CONSERVATION COMMISSION AGENDA

Date: Thursday, Sept 22, 2022

1. 7:00 – 21 Albemarle Rd – continued NOI – driveway expansion – DEP #239-932

2. 7:25 – 423 Albemarle Rd – NOI – addition and porch extension -- DEP #239-???

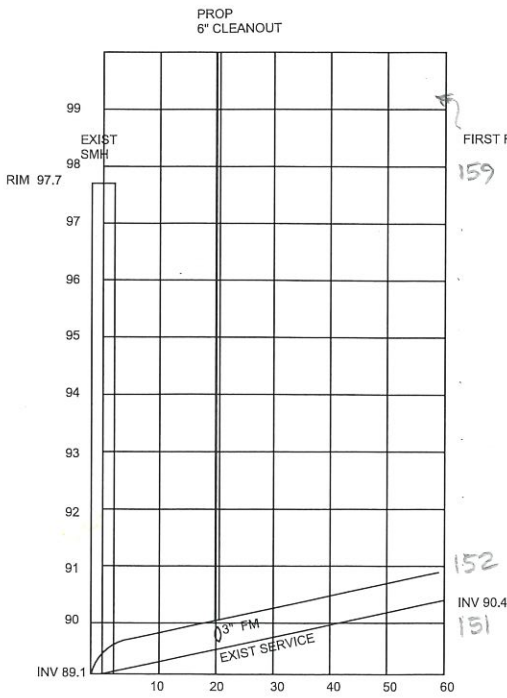
TOPO LINES ARE 1'
BUT LABELED AS 2'

PROPERTY LINES ARE
UNCLEAR

PROPERTY ANGLES
ARE UNCLEAR

TREE WASN'T LOCATED

**RJO'CONNELL
& ASSOCIATES, INC.**
CIVIL ENGINEERS, SURVEYORS & LAND PLANNERS
DATE: 09/13/2022 SCALE: 1"=20'
**QUANTITY OF PROPOSED DEGRADED AREA
(SK-2)**
100 BOULDER ROAD
NEWTON, MA

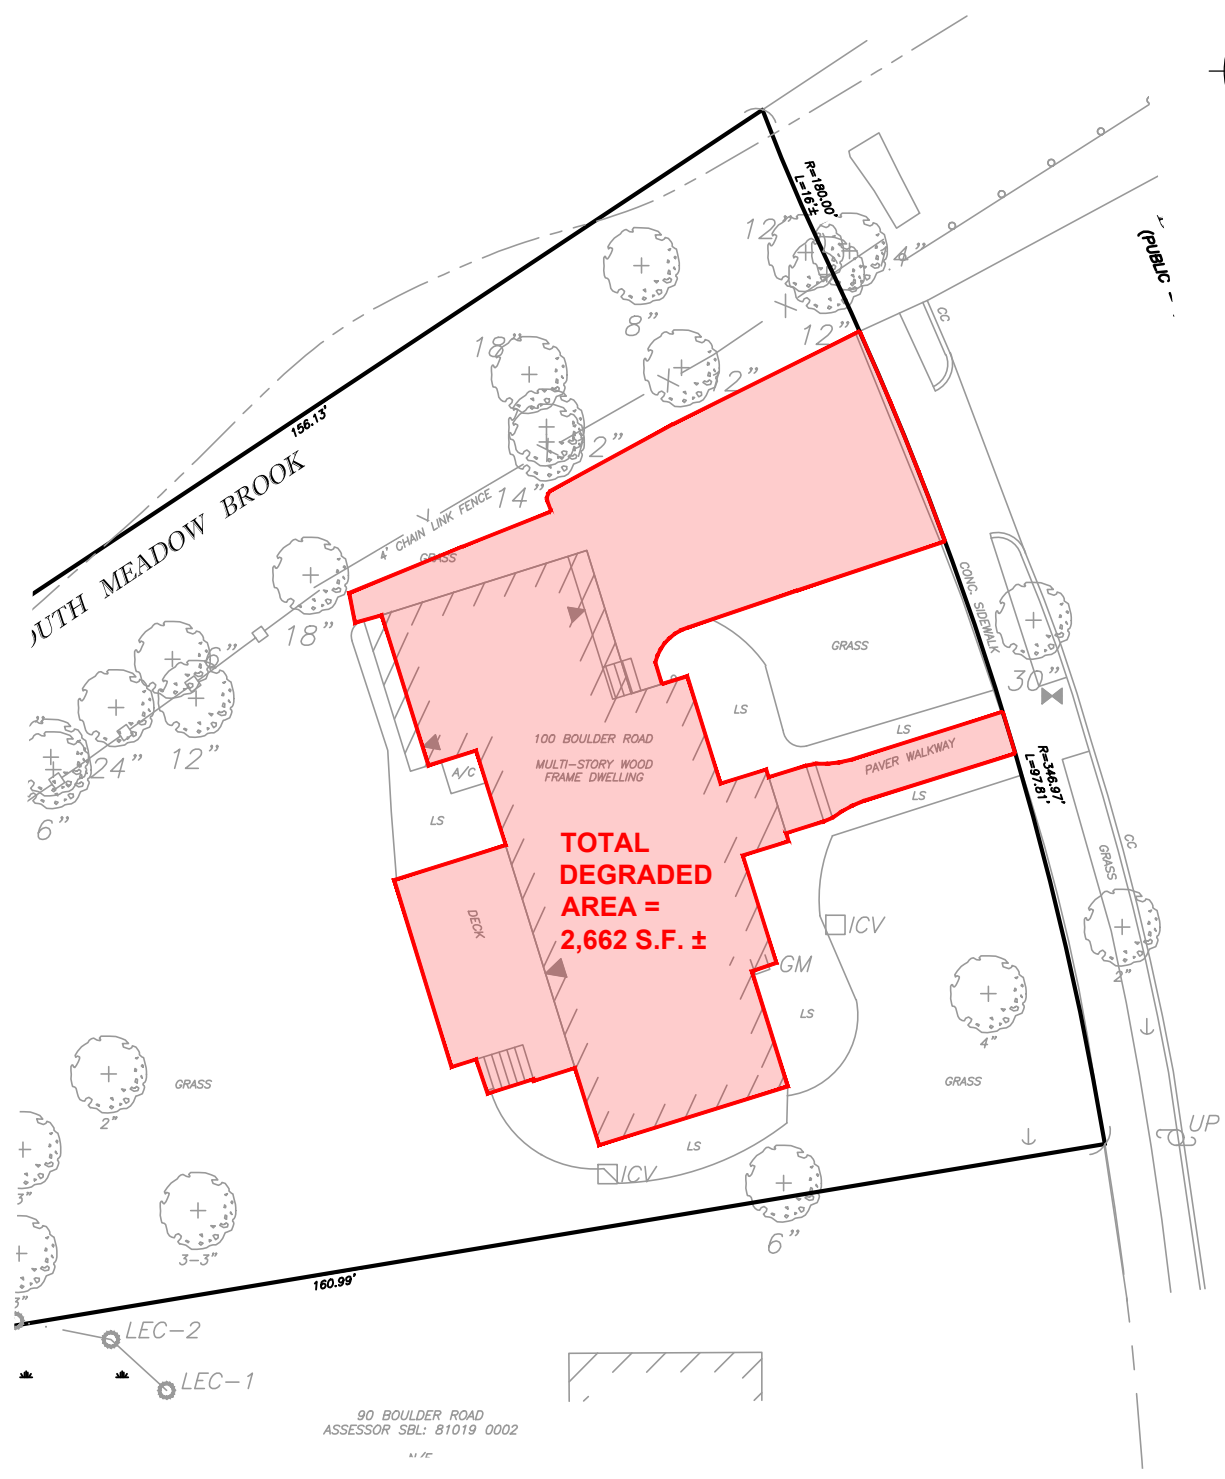
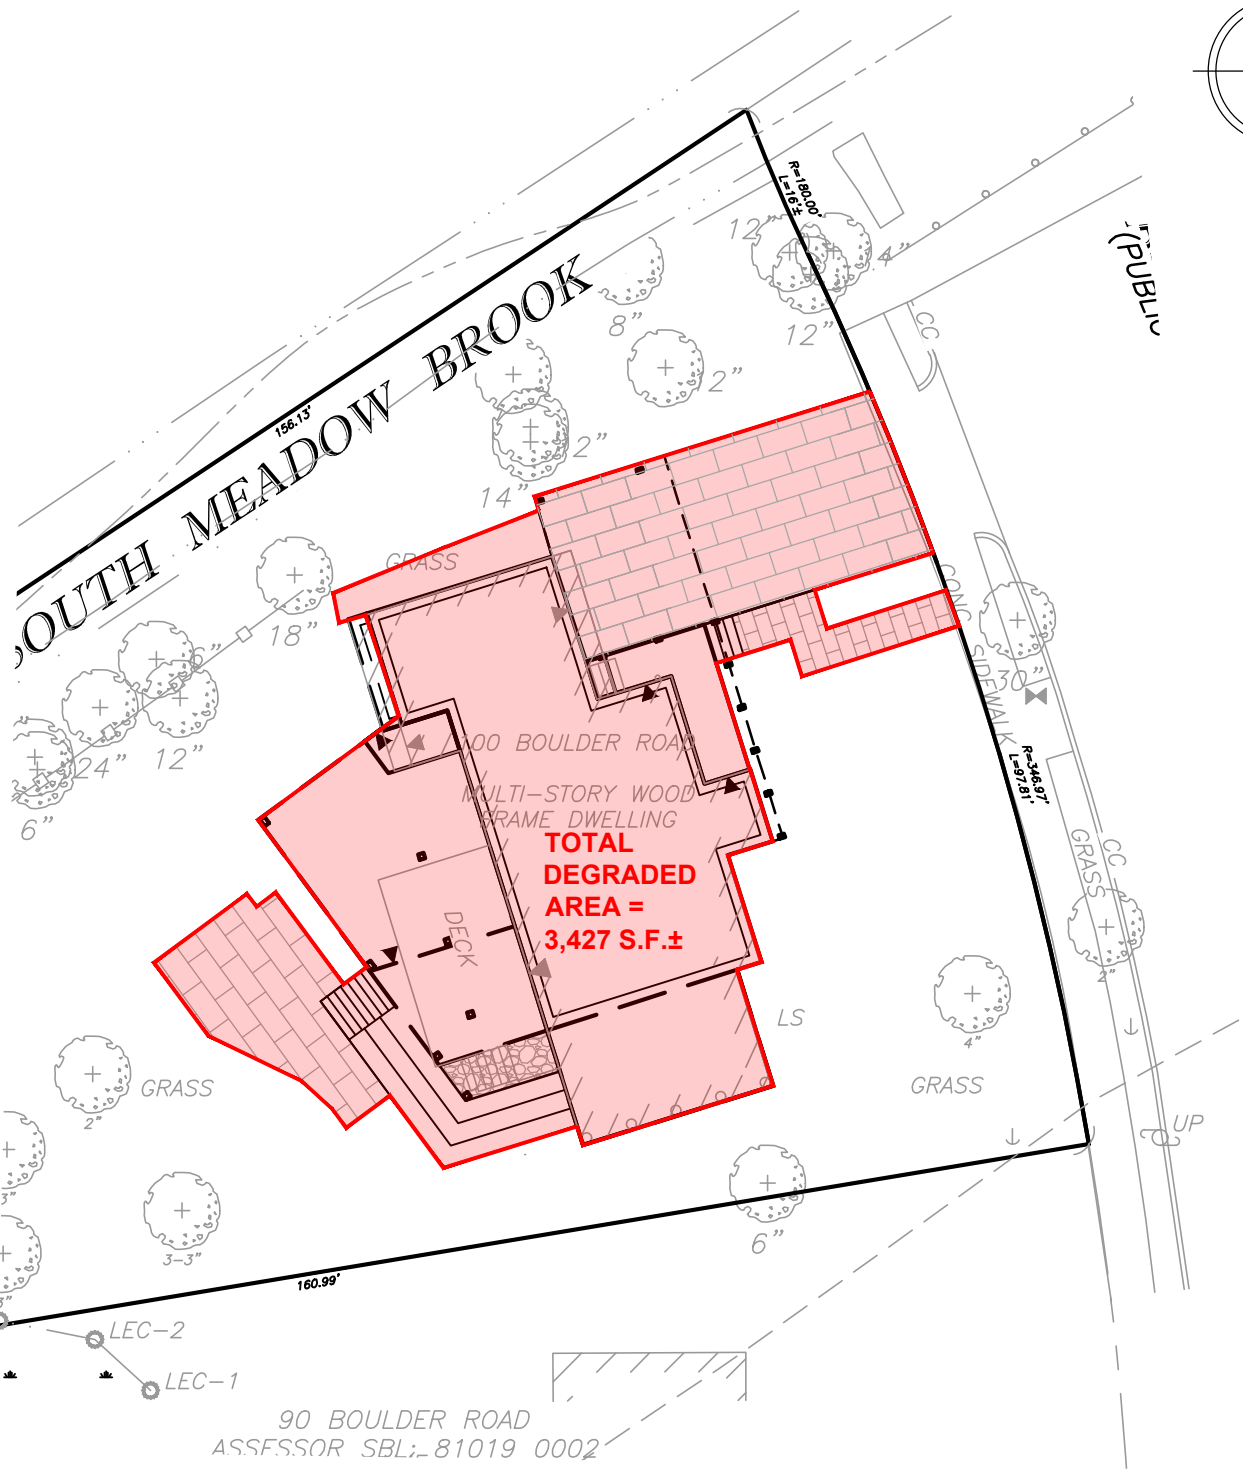
- The applicant's materials indicate that the proposed revisions would result in an increase in degraded area of 765 sf.
- Documents Presented. Revised plans

- A revised planting plan is needed that meets the RFA requirements for mitigation (i.e., at least 1,530 sf of conversion of lawn to fully natural area). Note: Plantings in lawn are not "restoration" as defined in the regulations.
